**CITY OF EVERETT
REQUEST FOR BIDS NO. 25-66
ADDENDUM NO. 3**

Project: #ENG-25-66

This **Addendum No. 3** is issued to amend the Request for Services for **Request for Bids for ENG-25-66 Woodland Playground Renovation**.

ELECTRICAL DETAILS

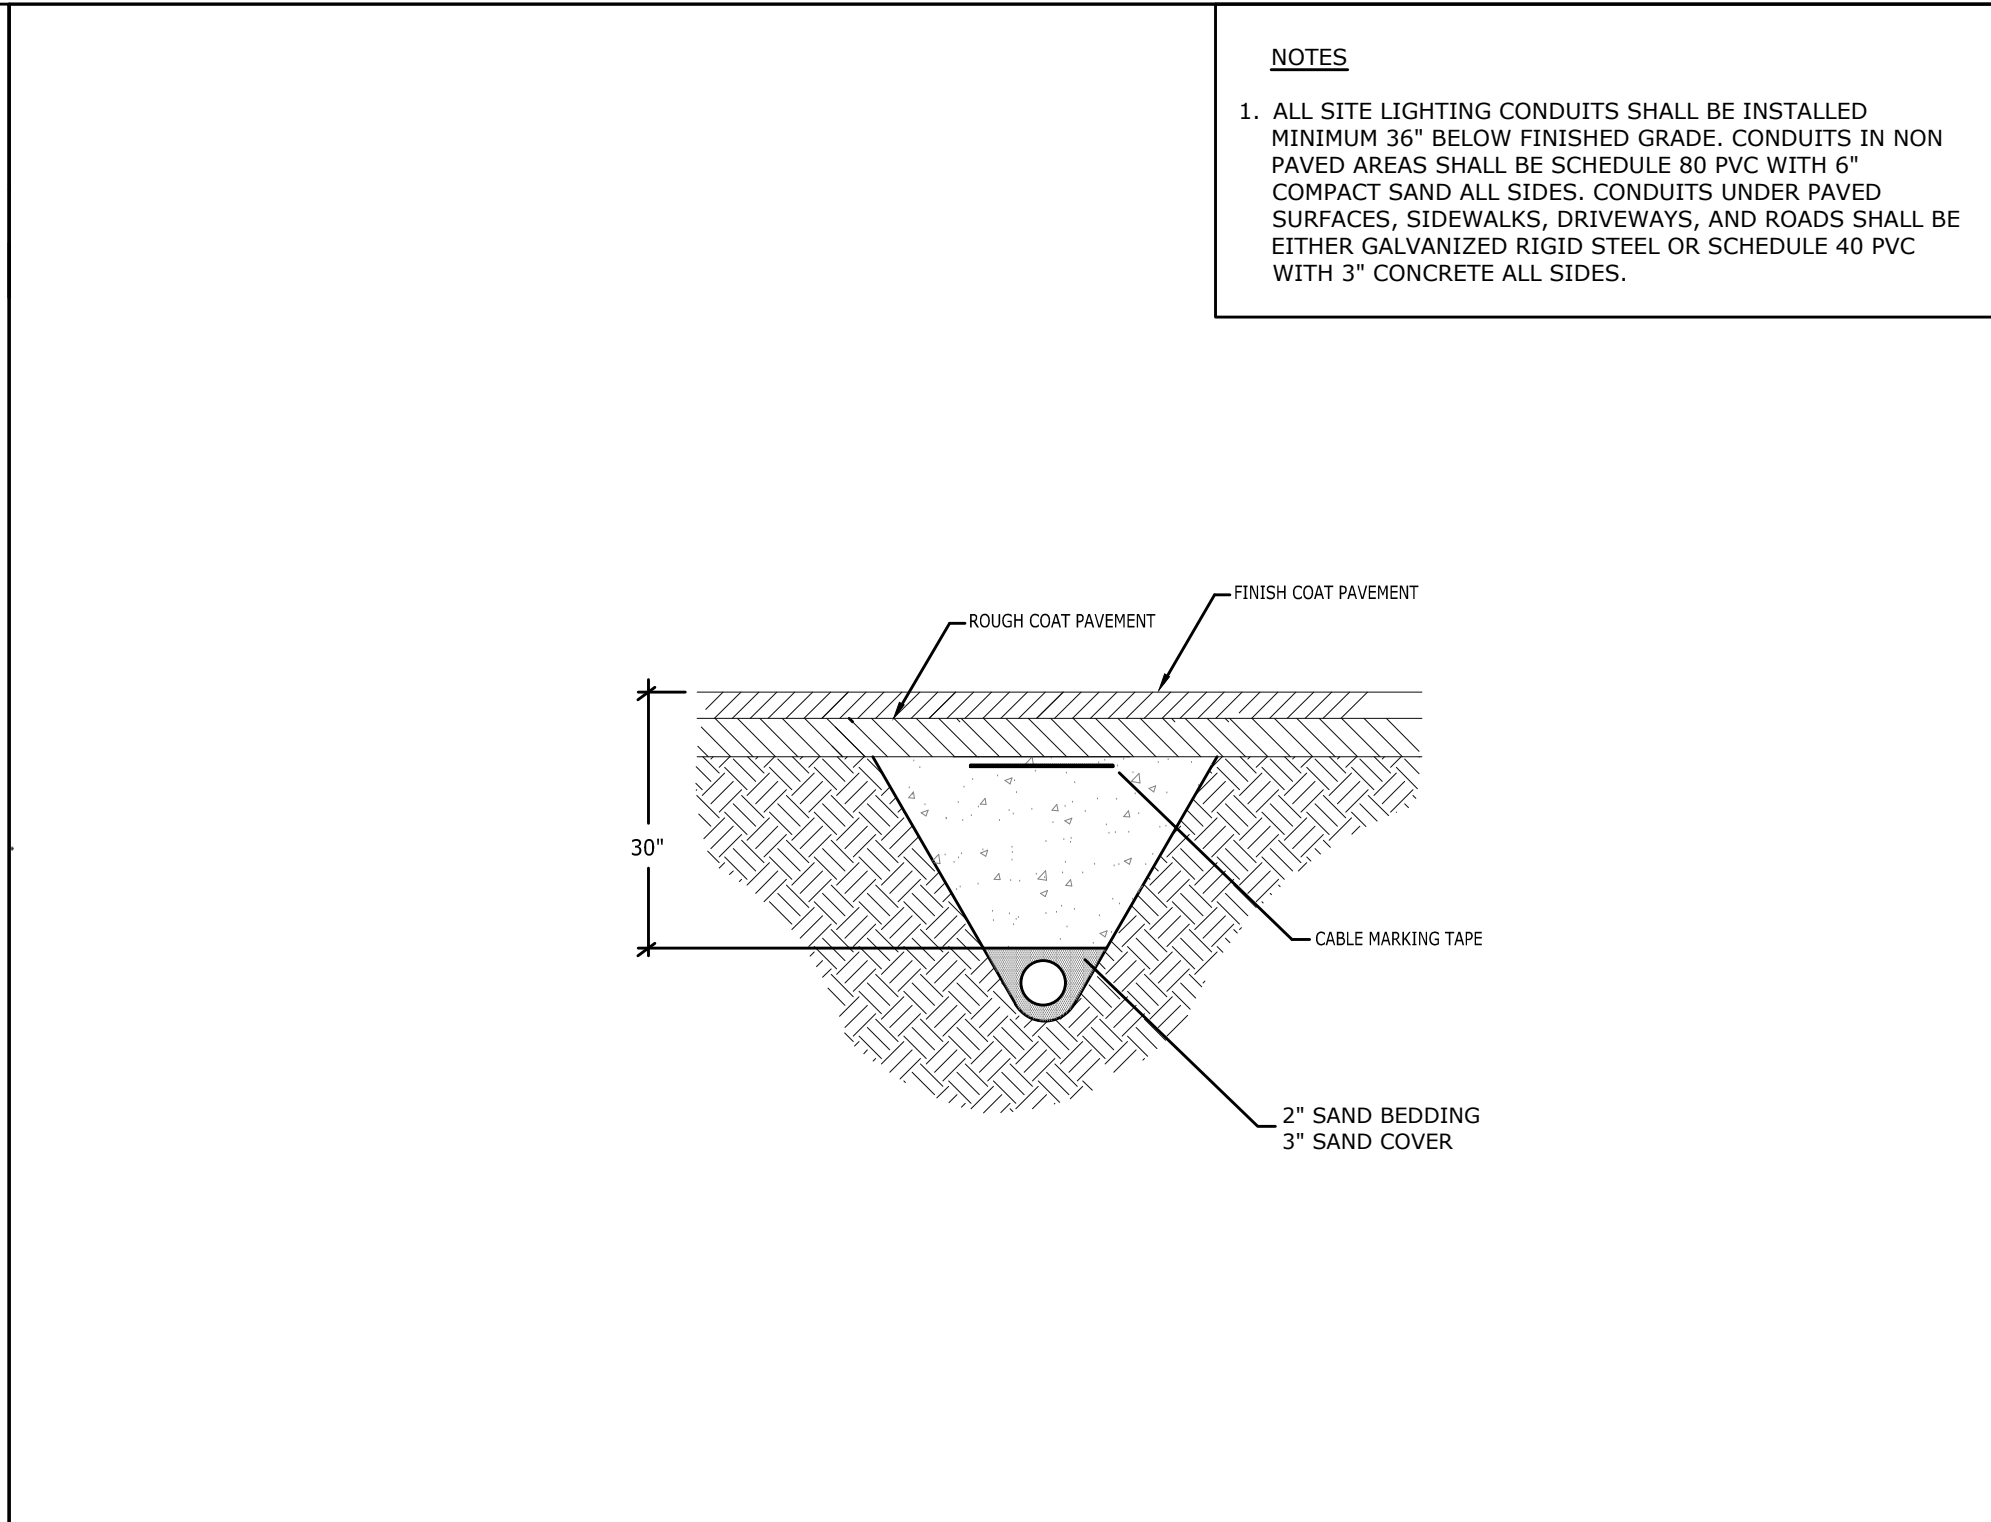
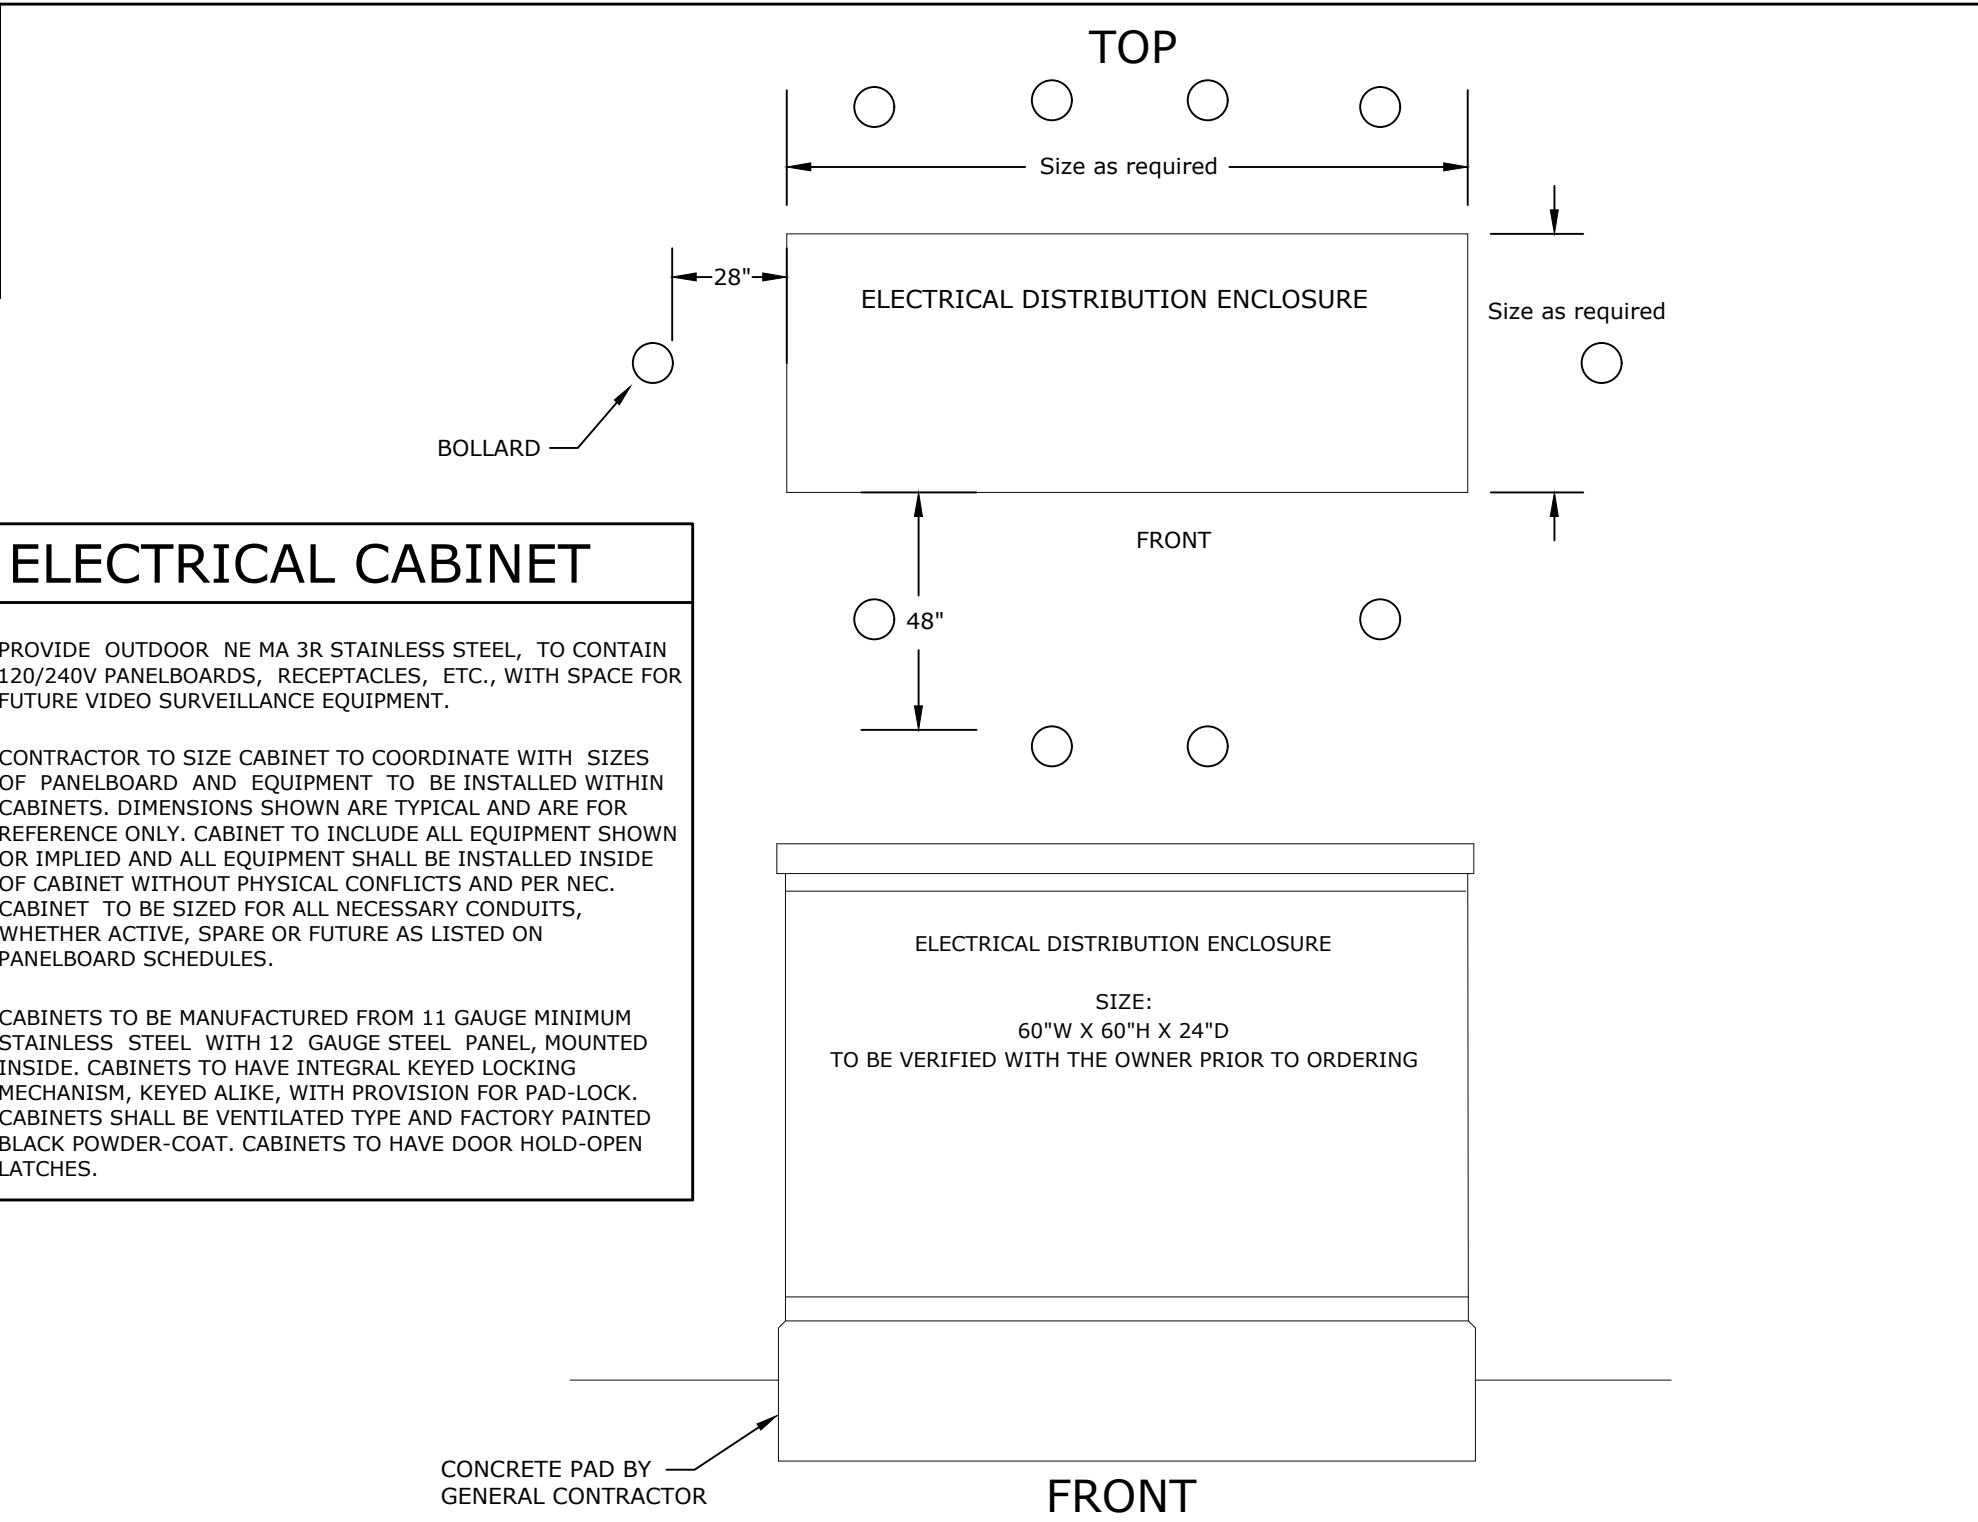
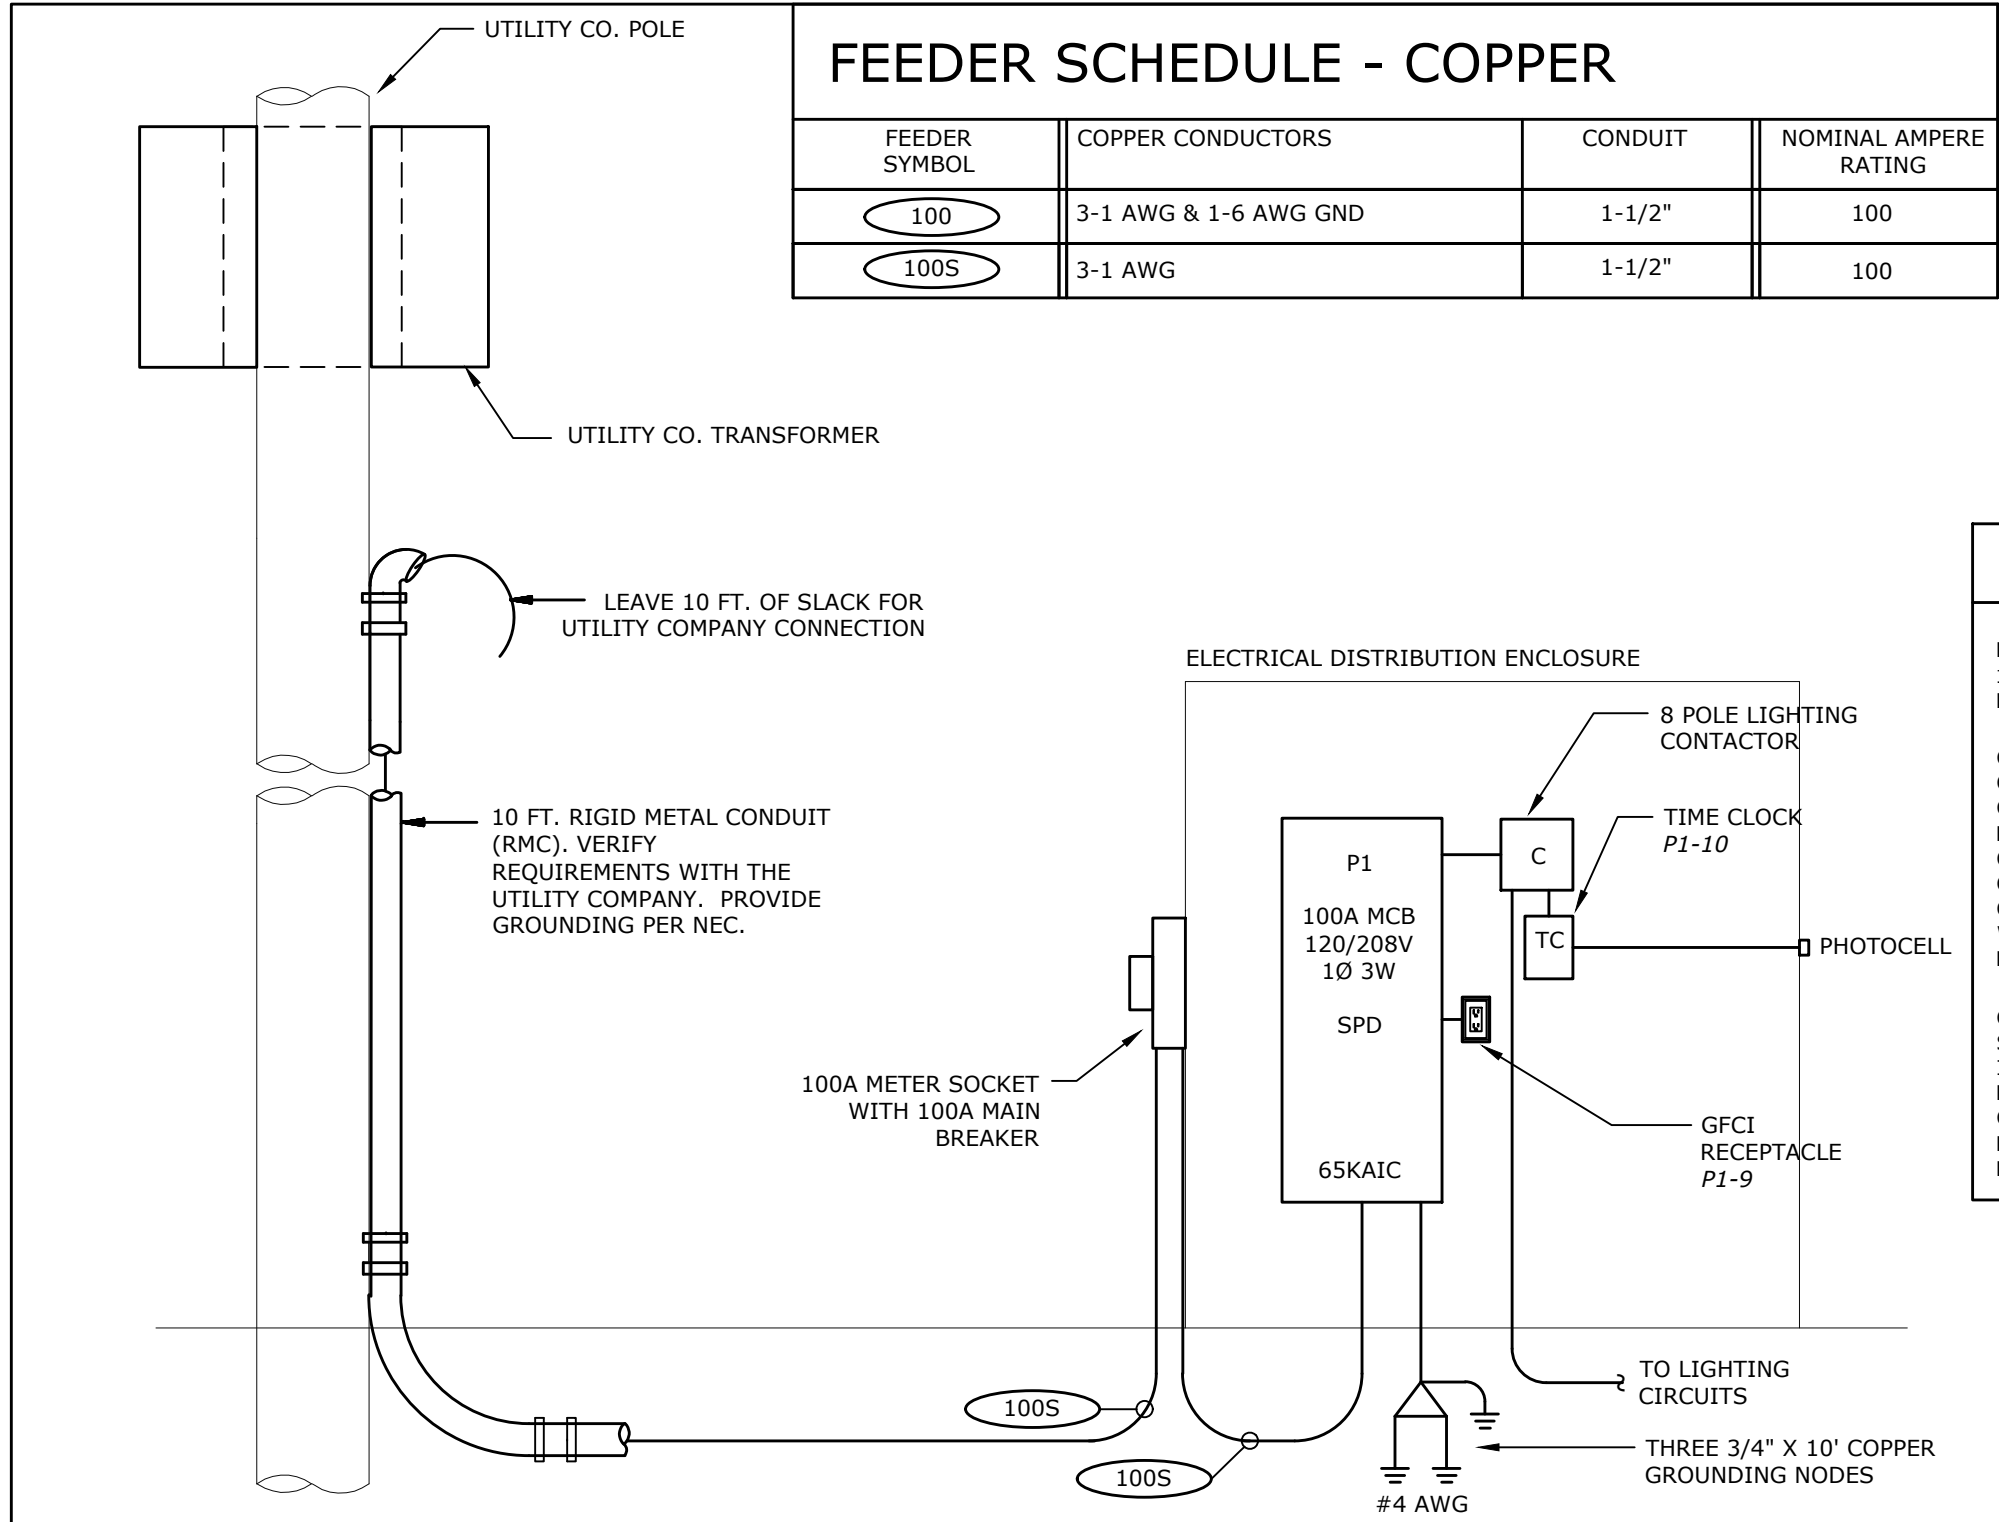
17. Are electrical permit fees for the project waived?
RESPONSE: Contractor is to pay all permit fees as required
18. Note 5 on drawing E1 calls for AASHTO 20 rated handholes. Handhole details on drawing E2 call for Quazite Tier 15 rated handholes. Please confirm that handhole are to have a Tier 15 rating as Quazite does not make AASHTO 20 rated handholes.
ART ELECTRICAL ENGINEER RESPONSE: Handholes are to be Quazite Tier 15 rated, consistent with the details shown on drawing E2. AASHTO H20 rating is not required unless the handholes are located within vehicular traffic areas.
If any handholes are installed in a roadway, driveway, or area subject to vehicle loading, the contractor shall provide traffic-rated (AASHTO H20) handholes suitable for that condition. Otherwise, Tier 15 is acceptable for all non-vehicular locations. Please coordinate field locations accordingly.
